HISTORIC AND DESIGN REVIEW COMMISSION

HDRC CASE NO: 2022-319
ADDRESS: 302 FURR DR
LEGAL DESCRIPTION: NCB 6695 BLK 4 LOT 28
ZONING: R-6, H
CITY COUNCIL DIST.: 7
DISTRICT: Monticello Park Historic District
APPLICANT: Arash Pazouki/PEBBLE DAWN PROPERTIES LLC
OWNER: Arash Pazouki/PEBBLE DAWN PROPERTIES LLC
TYPE OF WORK: Deconstruction and reconstruction of a rear accessory structure
APPLICATION RECEIVED: May 23, 2022
60-DAY REVIEW: Not applicable due to City Council Emergency Orders
CASE MANAGER: Claudia Espinosa

1. Deconstruct the existing, rear accessory structure at 302 Furr.
2. Reconstruct the rear accessory structure.

1 PROPOSED RECONSTRUCTED GARAGE PLAN
SCALE: 1/8" = 1'-0"

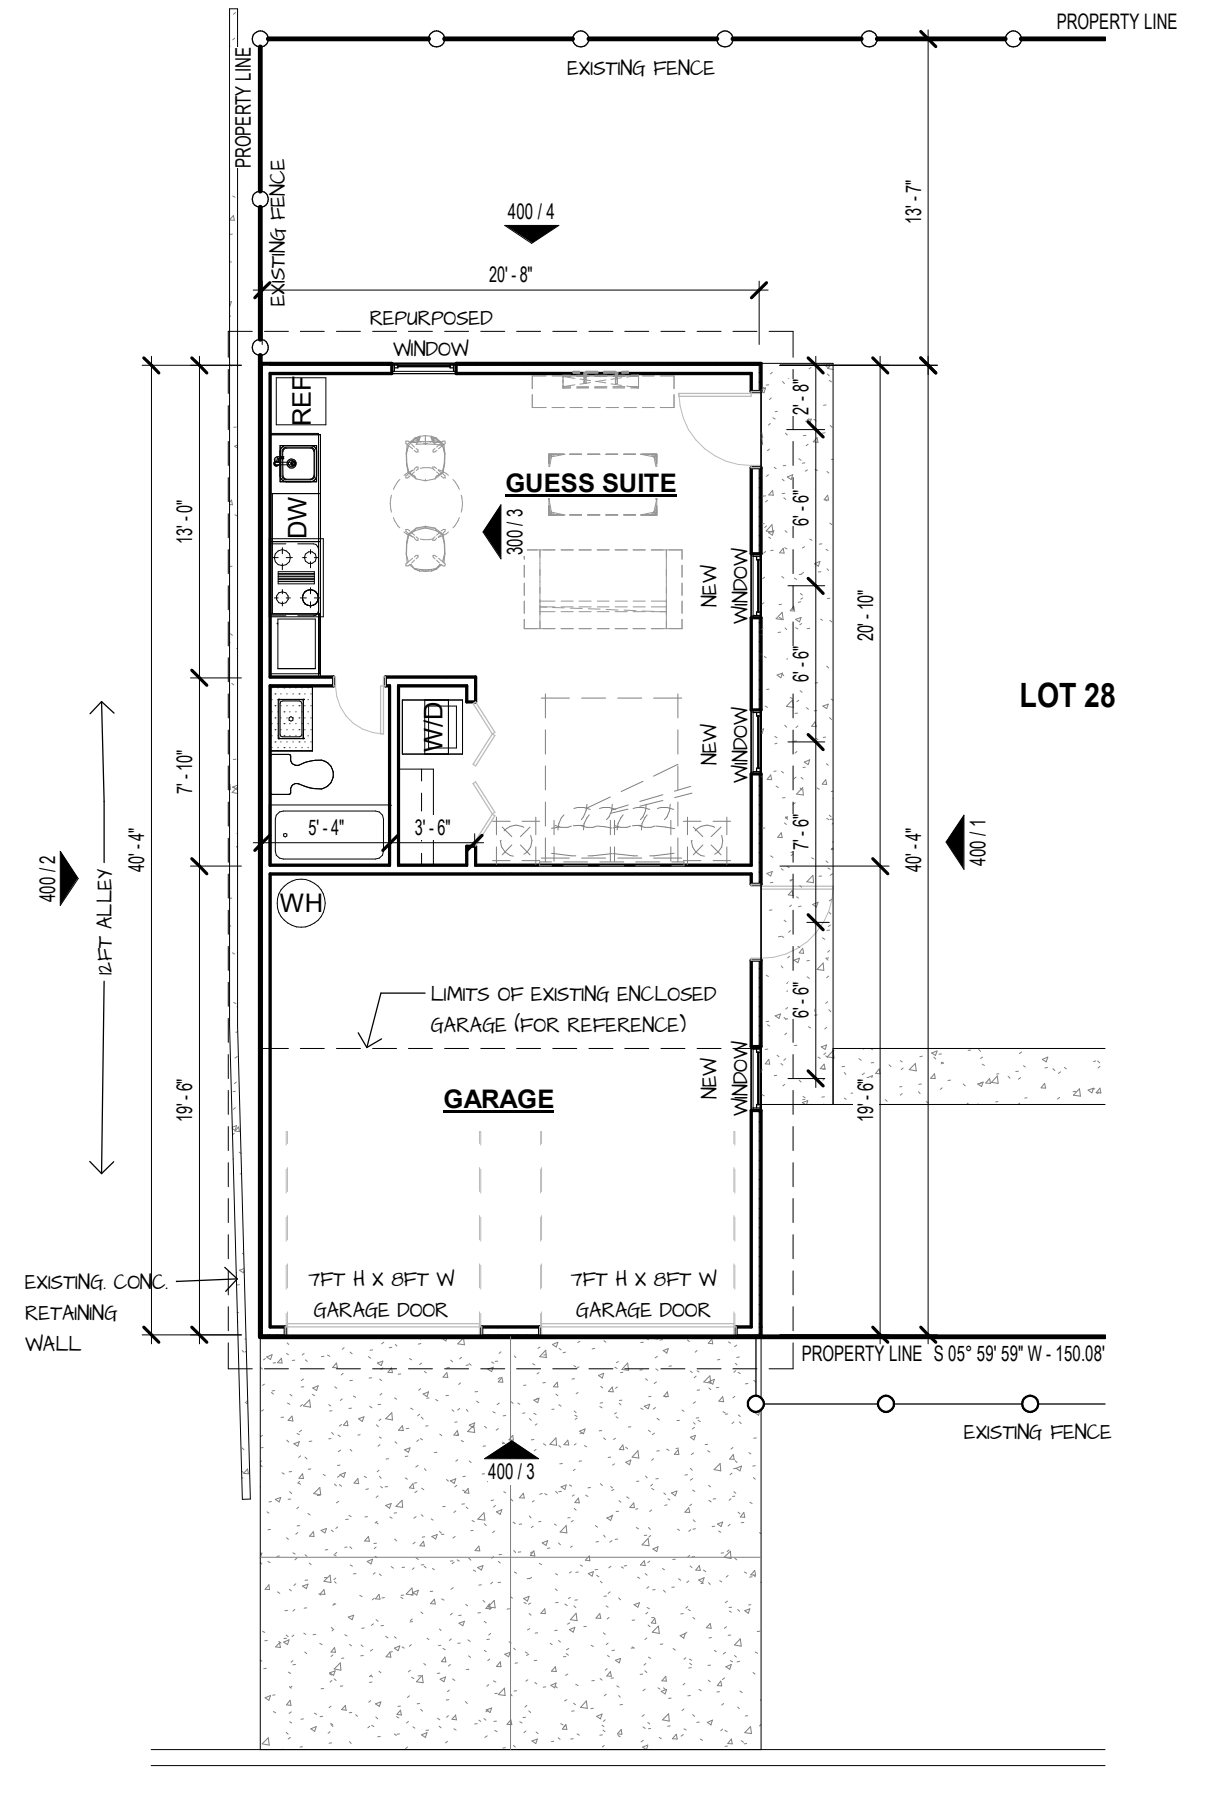
- c. **RECONSTRUCTION (Setbacks & Orientation)** – The applicant has proposed to reconstruct the rear addition to feature a setback that matches the existing structure's. While staff finds this setback to be appropriate and consistent with the original, staff finds that the applicant is responsible for obtaining any required variances.

- d. **RECONSTRUCTION (Massing & Footprint)** – The applicant has proposed to reconstruct the rear accessory structure to feature a footprint of approximately 800 square feet. The existing, rear accessory structure features a footprint of approximately 505 square feet, not including a carport/awning structures that extends over the property line. The primary historic structure at 302 Furr features an original one story form with a two story addition at the rear. Generally, staff finds the proposed reconstructed accessory structure's footprint to be appropriate and consistent with the Guidelines.

4 EXTERIOR ELEVATION - WEST
SCALE: 3/16" = 1'-0"

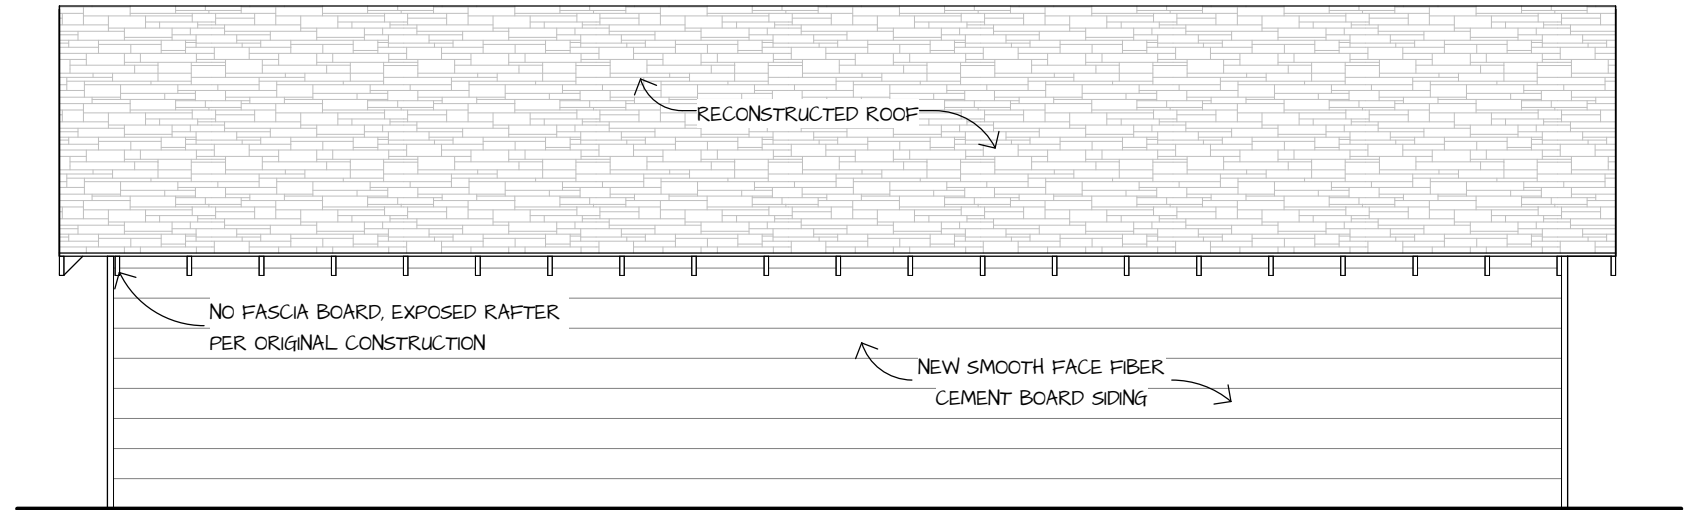
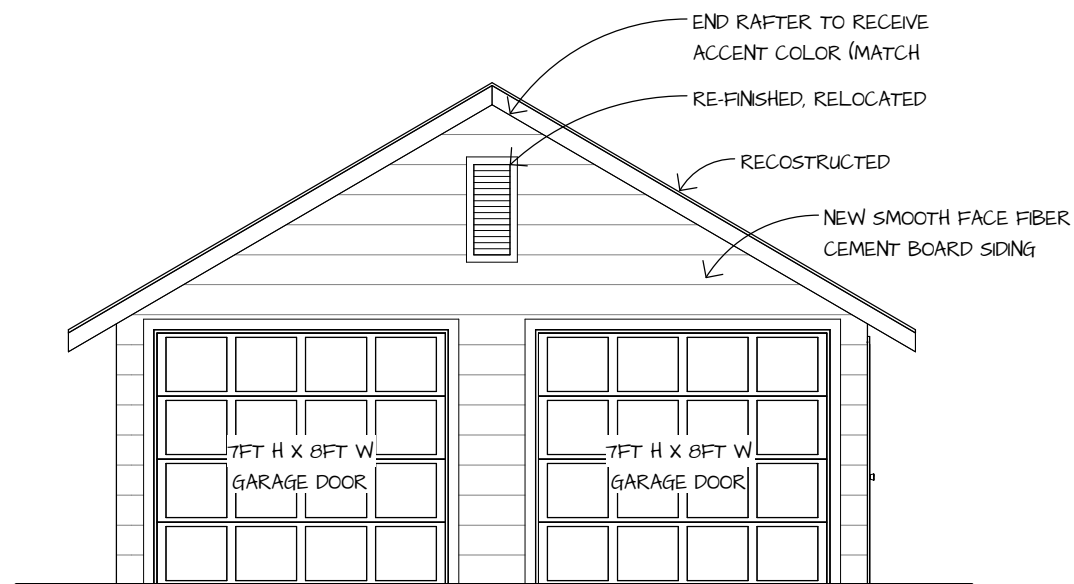
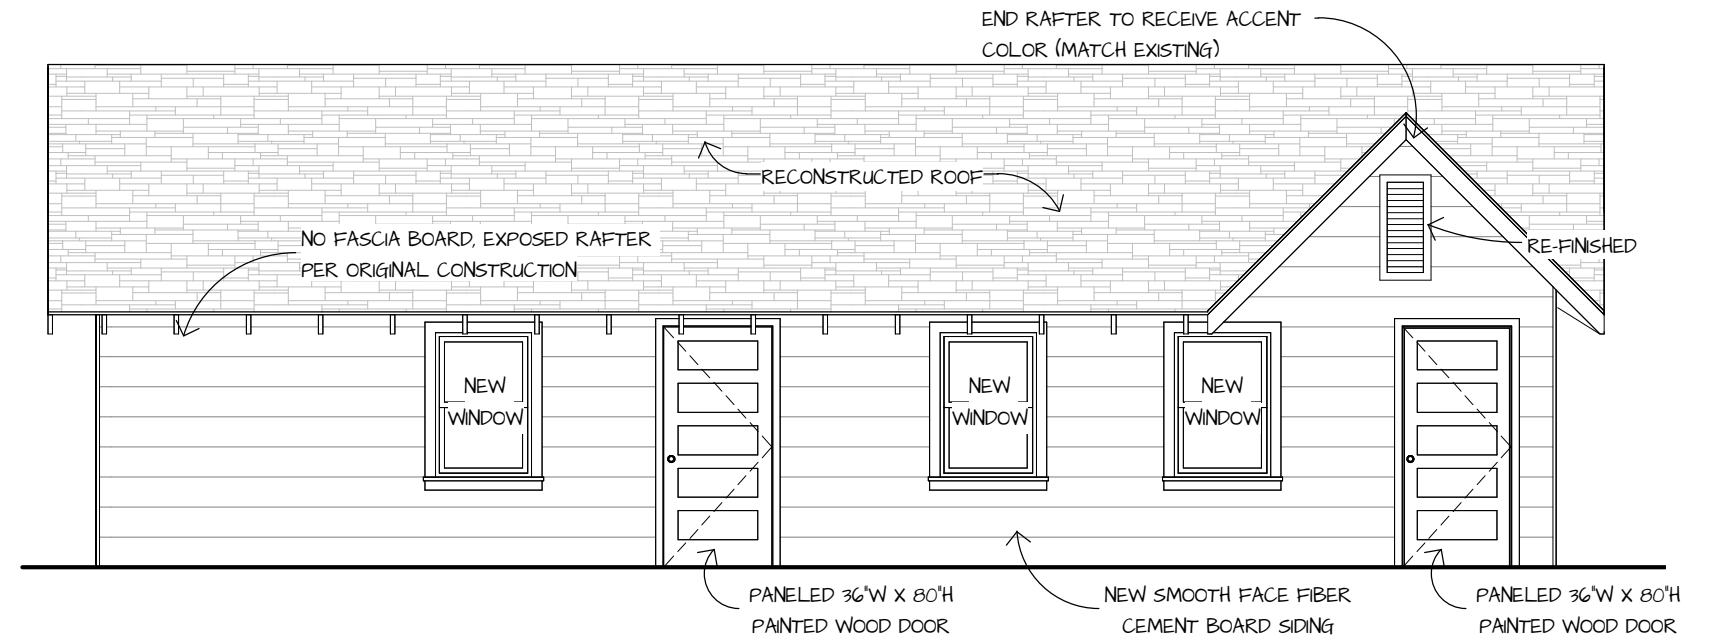
- e. **RECONSTRUCTION (Materials)** – The applicant has proposed to salvage many materials of the existing, rear accessory structure and has proposed new materials. The applicant has proposed to install new garage doors, new windows, new composite siding, new wood doors, and a shingle roof. Generally, staff finds the proposed materials to be appropriate; however, staff finds that the applicant should install garage doors that are either wood or feature a wood appearance with true window lites, that the proposed composite siding feature an exposure of four inches and a smooth finish, and that the proposed windows be wood or aluminum clad and be consistent with staff's standards for windows in new construction. Additionally, staff finds that existing, wood windows should be reused as well as any existing wood siding or framing materials.

- i. That the applicant submit a detailed salvage plan to OHP staff detailing the exact materials that will be salvaged and reused on site. This should be submitted to staff for review and approval prior to the issuance of a Certificate of Appropriateness.
2. Staff recommends approval of item #2, the reconstruction of the rear accessory structure based on findings c through e with the following stipulations:
 - i. That the proposed new garage doors be wood or feature a wood appearance with true window lites.
 - ii. That the proposed composite siding feature a smooth finish with a four inch exposures.
 - iii. That the proposed new windows be wood or aluminum clad wood and be consistent with staff's standards for windows in new construction.
 - iv. That wood windows and doors, among other wood materials from the existing structure be salvaged and reused in the proposed new construction.
